CUT PATTERN	
BACK FRAME NO.	
BASE FRAME NO.	
WOOD PATTERN

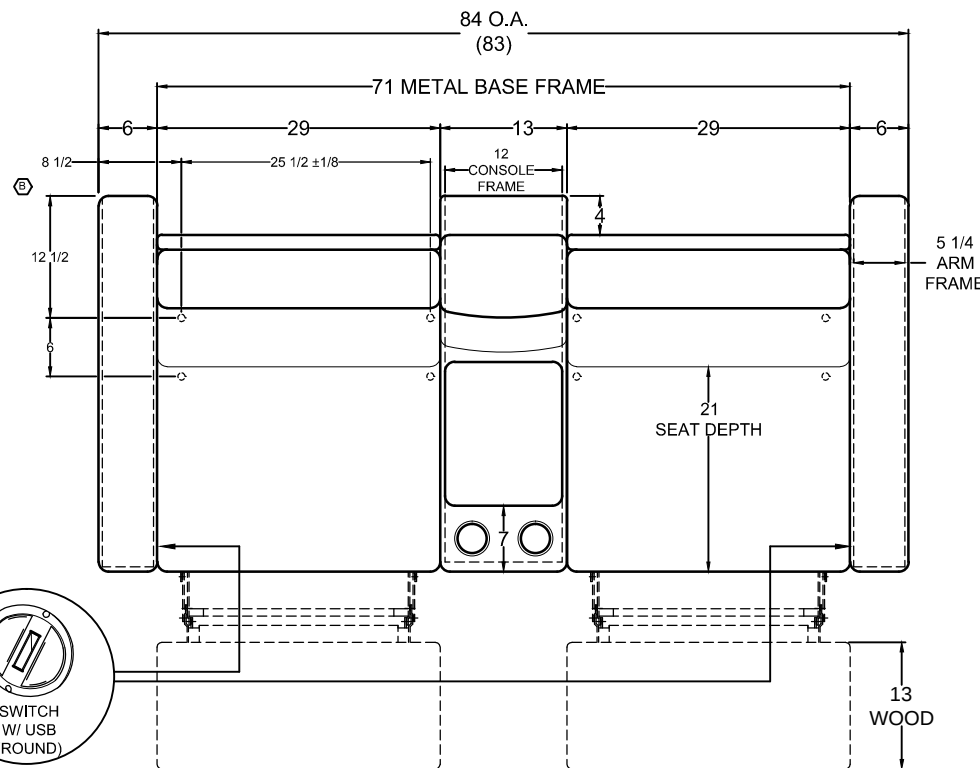
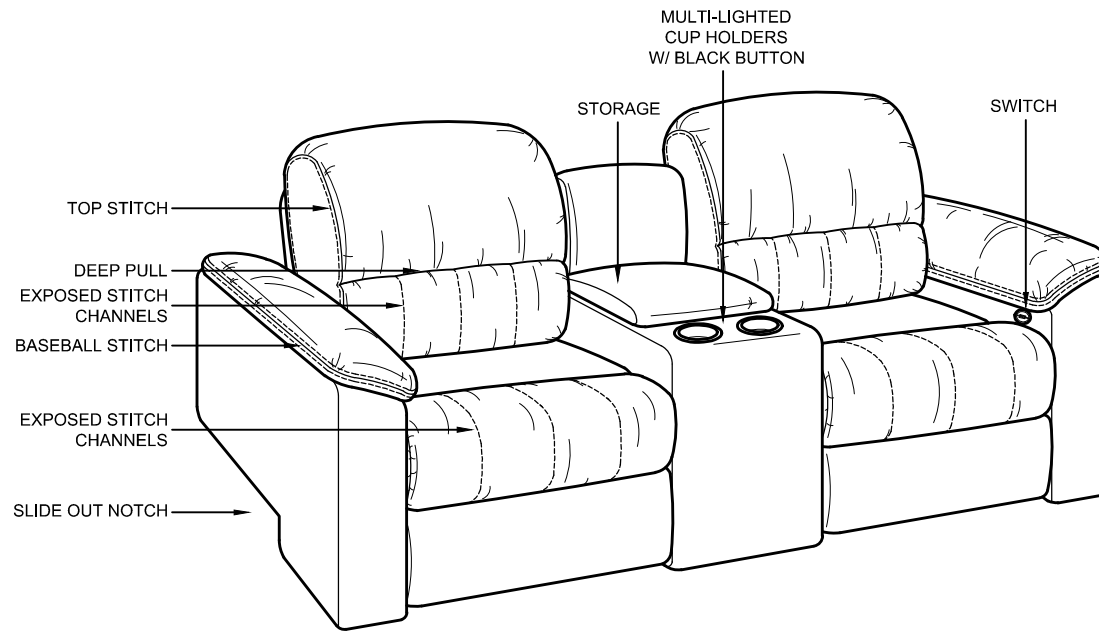
JA	C	ADD 13\" WOOD KICK PANEL DIMENSION TO DRAWING. (REF. ECO #002-2021)	02.09.21
JA	B	PRODUCTION UPDATE: CHANGE BOLT PATTERN. PER RL, [1] CHANGE HEIGHT TO 39\"; WAS 37\". [2] CHANGE	01.19.21
JA	A	FRAME HEIGHT TO 33\"; WAS 31\".	05.21.2020
REVISIONS
